JOB Seattle Kero Nursing Home
LOCATION Seattle, WA
CONTRACTOR Sellen Constr Co.

Column Details

JOB # 06-71 KEIRO NURSING HOME
ERECTION PLAN, NOTES

JOB # 102-91 KEIRO NURSING HOME
SECTIONS.

COLUMN DETAILS

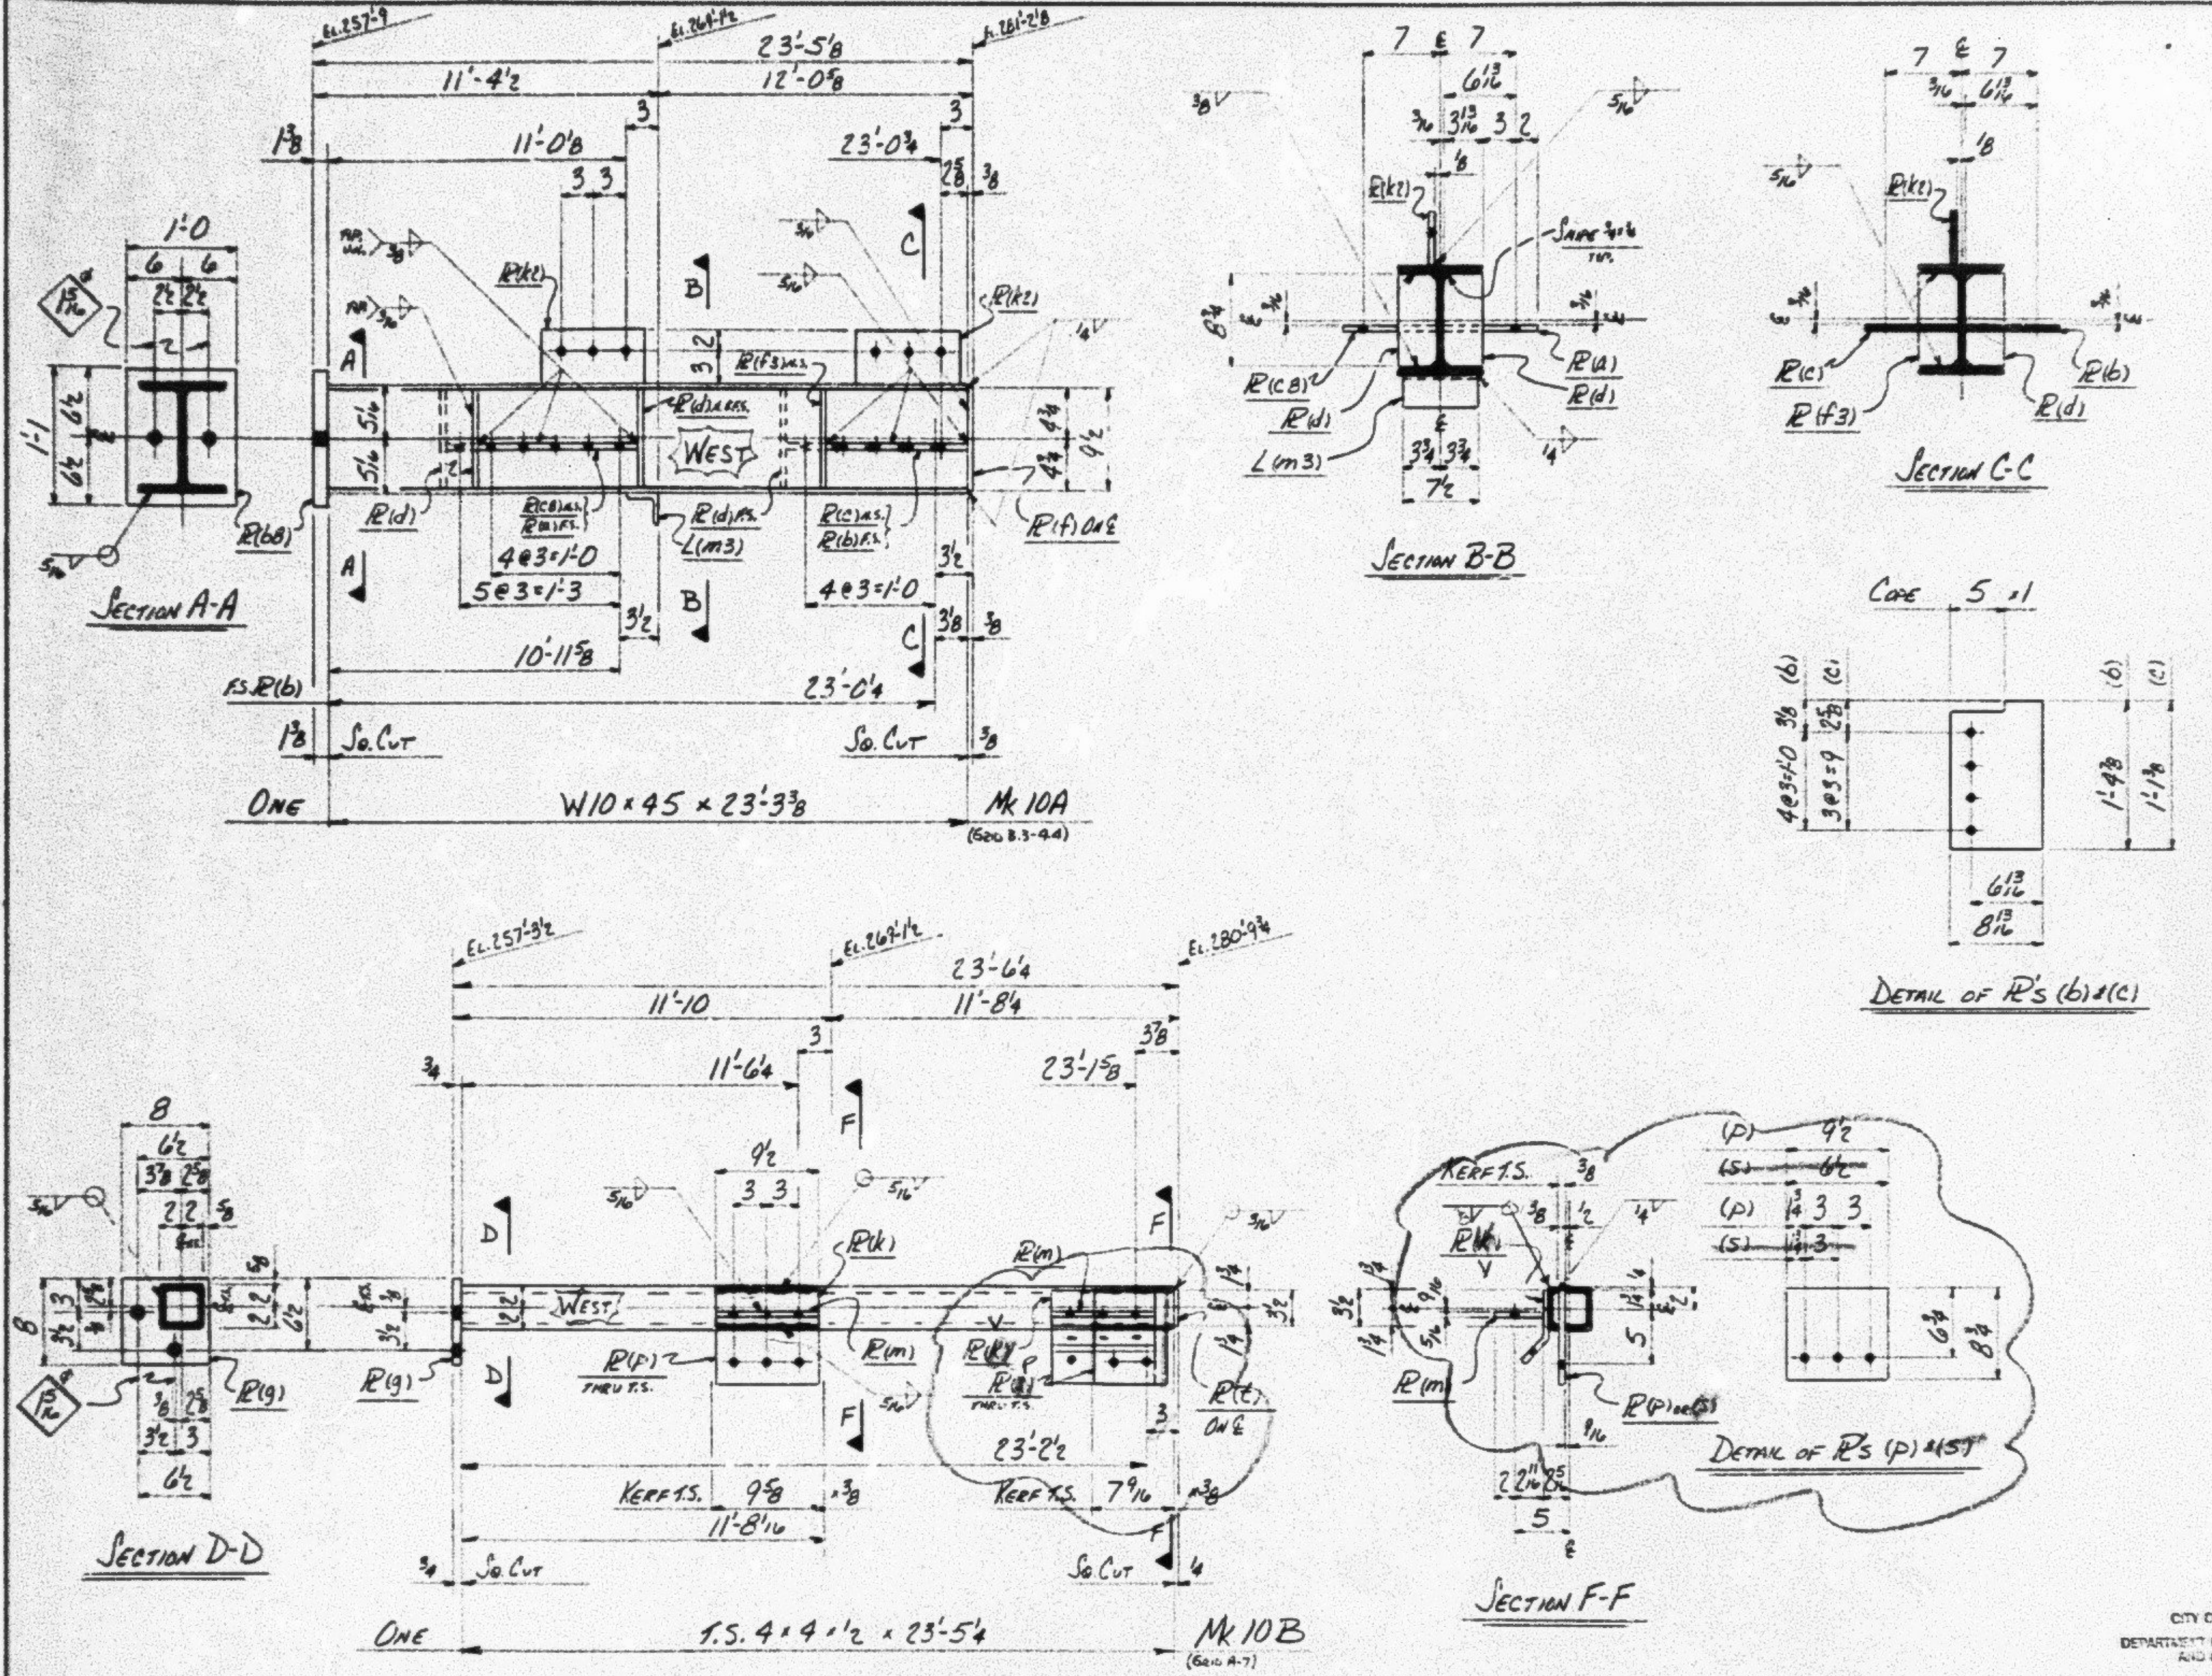
☐ CONFORMS TO DESIGN CONCEPT
☐ CONFORMS TO DESIGN CONCEPT WITH REVISIONS AS SHOWN
☒ NON-CONFORMING-REVISE AND RESUBMIT
[illegible]
DWagner 8/13/86
KPFF

FLOOR PLAN △

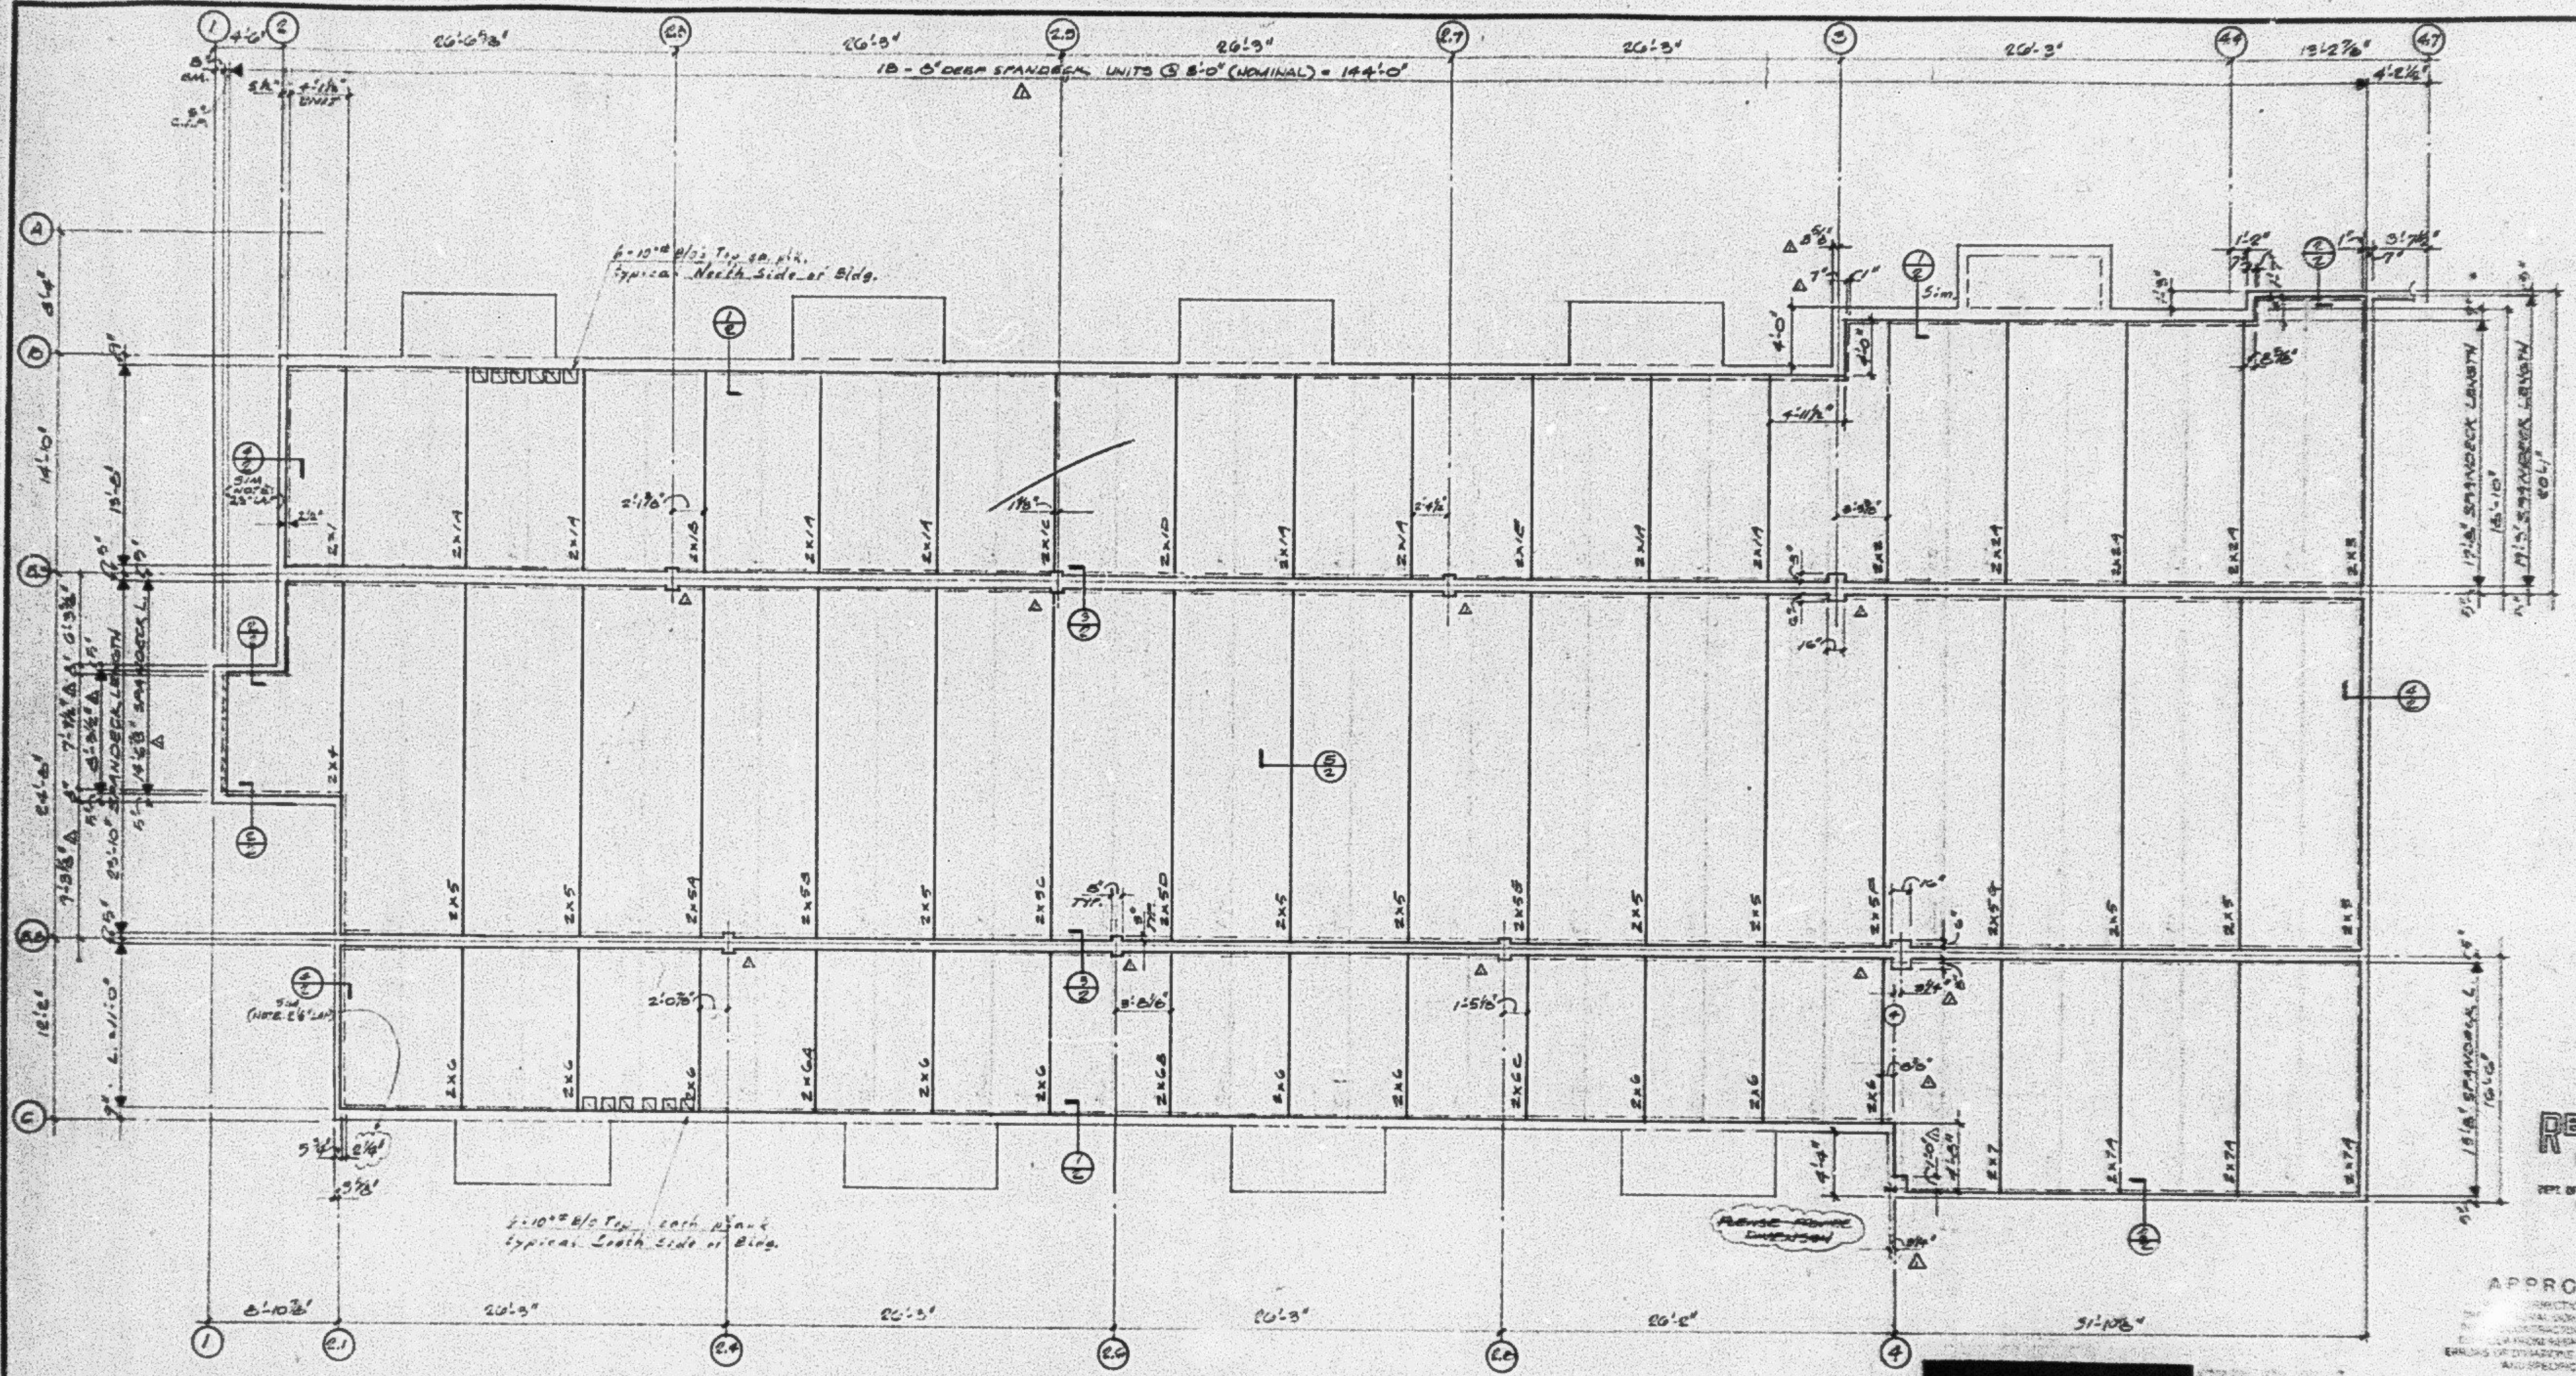
18 - 8" DEEP SPANDECK UNITS @ 8'-0" (NOMINAL) = 144'-0"
26'-6 3/8"
26'-3"
26'-3"
26'-3"
26'-3"
13'-2 7/8"
4'-2 1/2"
6"-10" E/O Top ea. plk. typical North Side of Bldg.
6"-10" E/O Top each plank typical South Side of Bldg.
Please Note Dimension
17'-8" SPANDECK LENGTH
18'-10"
19'-5" SPANDECK LENGTH
13'-8" SPANDECK L.
16'-6"
8'-10 3/8"
26'-3"
26'-3"
26'-3"
26'-2"
31'-10 3/8"
2x17
2x18
2x5
2x6
2x24
2x7

APPROVED
CORRECTIONS NOTED
ERRORS OF DIVERGENCE FROM DRAWINGS AND SPECIFICATIONS
KELLER CONSTRUCTION CO. INC
GENERAL CONTRACTOR
By GB Date 9-10-86
NOTE BLOCKOUT REQUIRED ON SUBMITTAL OF 8-27-86

CONNECTION BASE PLATE TO PANEL

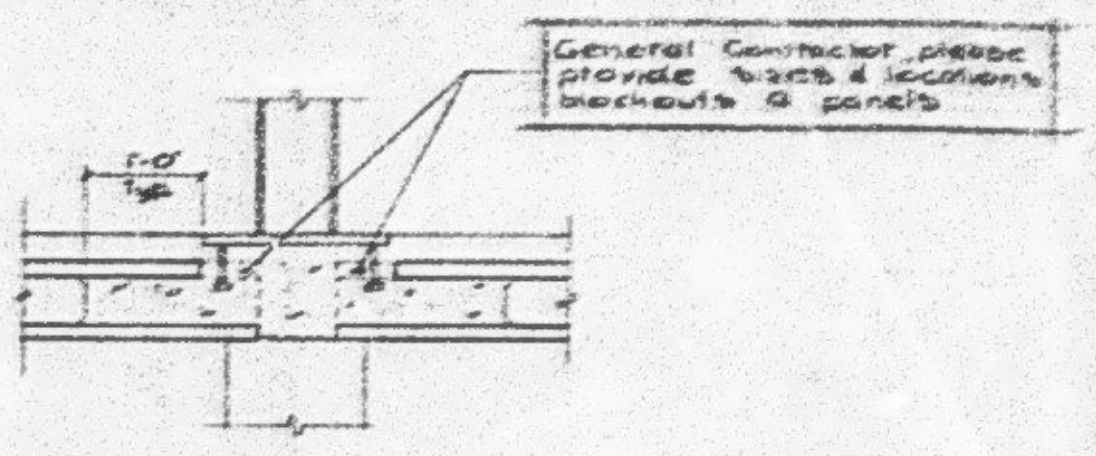
1'-0" Typ.
General Contractor, please provide sizes & locations blockouts @ panels

APPROVED
WITH CORRECTIONS NOTED
THIS APPROVAL DOES NOT RELIEVE THE SUBCONTRACTOR OR MATERIAL SUPPLIER FROM RESPONSIBILITY FOR ERRORS OR OMISSIONS FROM DRAWINGS AND SPECIFICATIONS
SELLEN CONSTRUCTION CO., INC.
GENERAL CONTRACTOR
By EB Date 9-10-86
Note Blockout revisions on submittal of 8-27-86

PANEL CROSS-SECTIONS △1

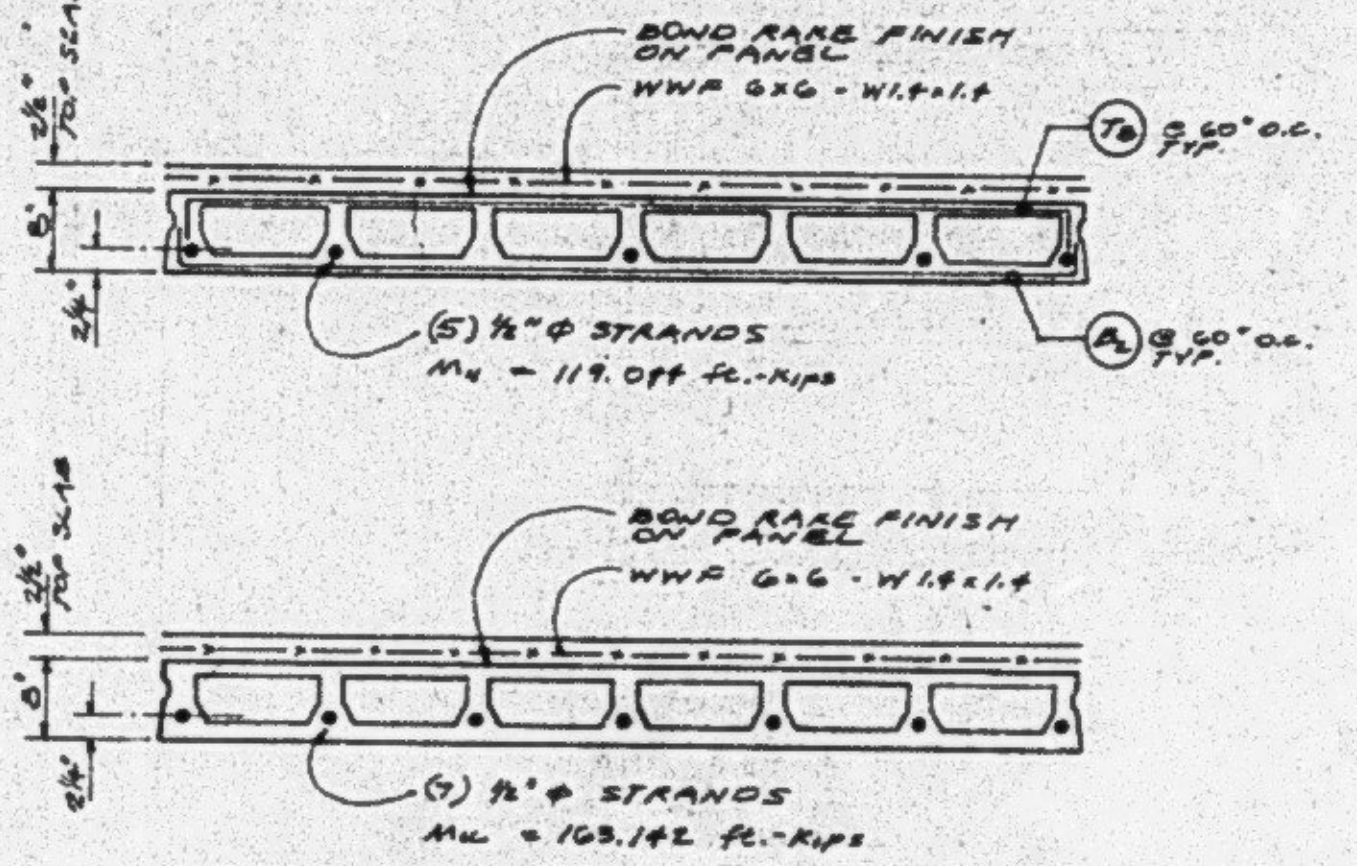
OK for 3 HR. per the approved code change in 1988. E.W.
